UNITED STATES PATENT AND TRADEMARK OFFICE

| APPLICATION NO. | FILING DATE | FIRST NAMED INVENTOR | ATTORNEY DOCKET NO. | CONFIRMATION NO. |
|-----------------|-------------|----------------------|---------------------|------------------|
| 09/347,845 | 09/30/1999 | YI YANG | 243/079 | 4401 |

Office Action Summary

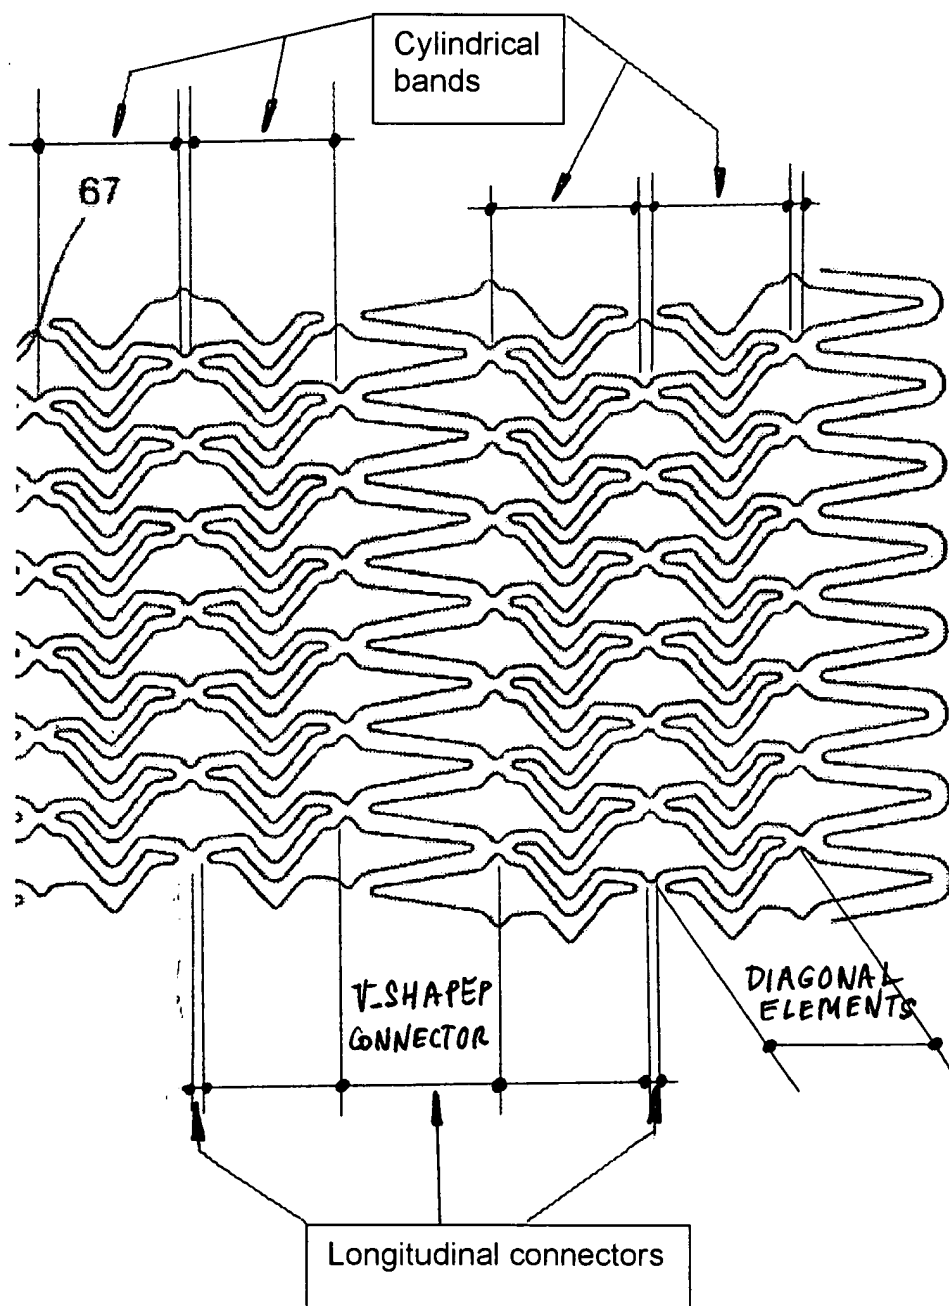
As to claims 1, 3-4, 8-11, and 24-25, VON OEPEN (Fig. 8 as copied and shown below; column 1, lines 36-39) discloses a zigzag pattern tubular stent (60) expandable from a contracted condition for easy introduction of the stent into a body lumen (a blood vessel) to an enlarged condition for supporting and keeping the body lumen (the blood vessel) open. Inherently, the stent is biased towards enlarged condition from a contracted condition (as recited in claims 4, 24-25) to support the body lumen. The stent comprises:

- A plurality of cylindrical bands of diagonal elements having generally arcuate shapes, arbitrarily assigned either a clockwise or counter clockwise orientation.
- A plurality of longitudinal connectors (I-shaped and V-shaped) extending substantially parallel to the longitudinal axis of the stent.
- The longitudinal connectors have a longitudinal dimension substantially smaller than a longitudinal dimension of the diagonal elements (as recited in claim 9).

The diagonal elements comprise 1st and 2nd generally straight portions having 1st

ends connected to preceding and succeeding diagonal elements and 2nd ends being connected together (as recited in claim 10).

- The diagonal elements of each cylindrical band are out of phase with any adjacent cylindrical band (as recited in claim 11).

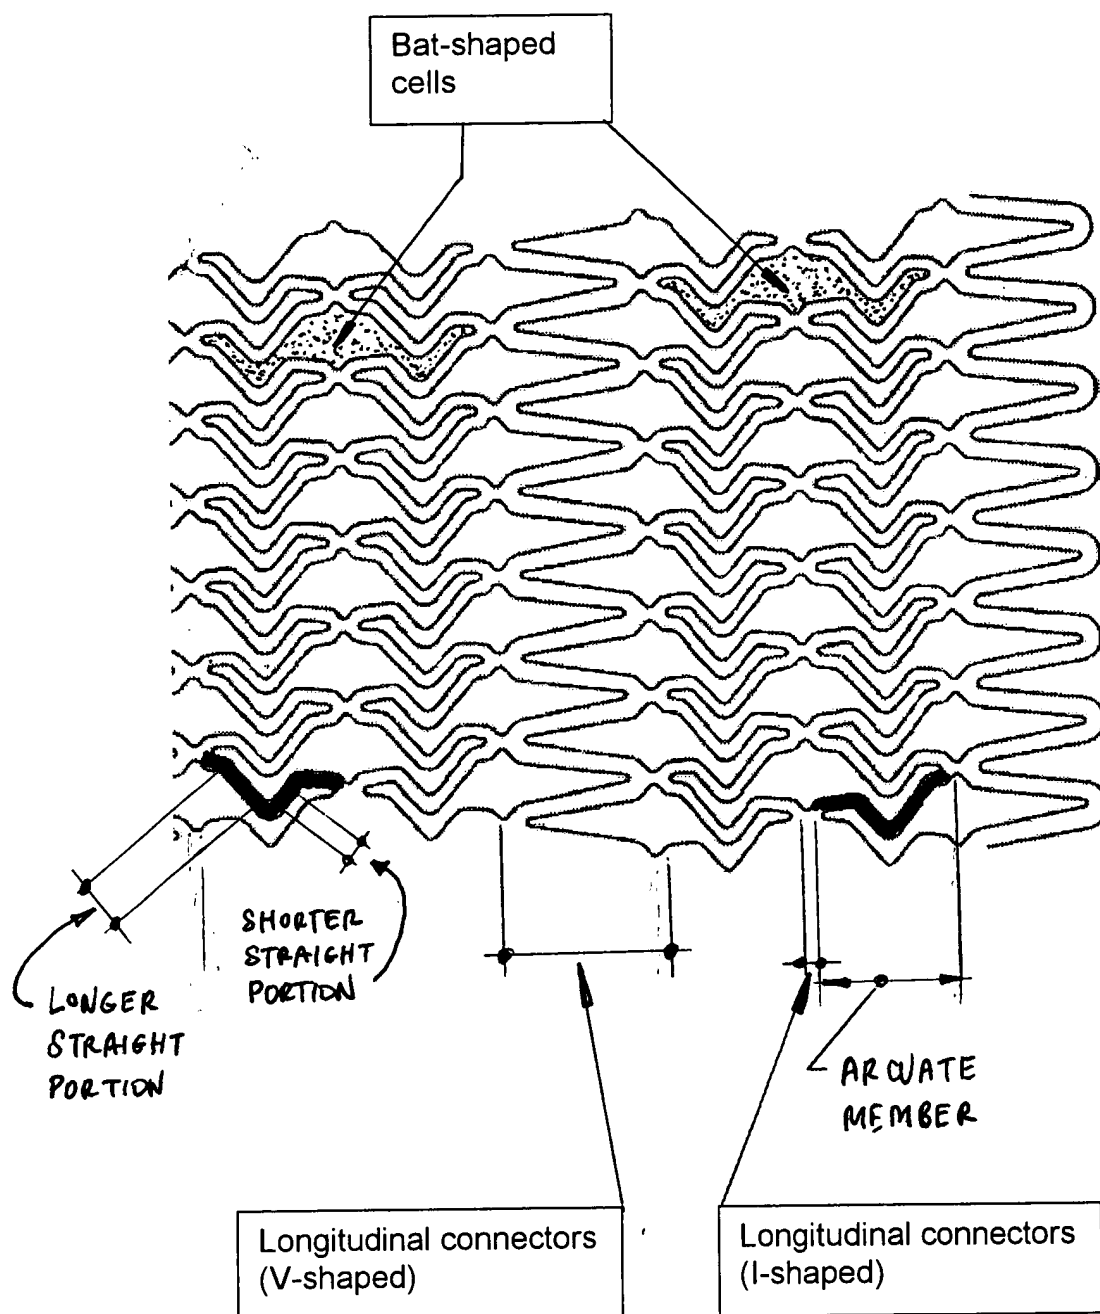
As to claims 12-15 and 17-22, VON OEPEN (Fig. 8 as copied and shown below; column 1, lines 36-39) discloses a tubular stent (60) comprising:

- Bat-shaped cells each having a head region, a tail region, opposing curved wing regions.
- Connectors (I-shaped or V-shaped) extending substantially parallel to a longitudinal axis (as recited in claims 12 and 15).

- The head and tail regions are aligned about the circumference of the stent, the wing regions have a generally V-shaped extending longitudinally away from the head and tail regions (as recited in claim 13).

- The cells are arranged sequentially about the circumference, thereby defining a cylindrical band (as recited in claim 14).
- The wing regions are defined by 1st and 2nd arcuate members, the 1st and 2nd arcuate members comprising a pair of generally straight portions connected to one another by a curved portion, and the curved portion defines an apex of the "V" shape curved wing regions, the apices all pointing substantially in a single direction (as recited in claims 17-18).

- The head regions and tail regions are defined by longitudinal connectors (I-shaped connectors), one of the straight portions of each of the first and second arcuate members is substantially shorter than the other generally straight portion of the respective arcuate member, and the longitudinal connectors define the tail region also define the head region of an adjacent cell (as recited in claims 19-21).

- The connectors comprise a longitudinal connector (V-shaped connector) extending between a wing region of a first cell and a wing region of an adjacent cell (as recited in claim 22).
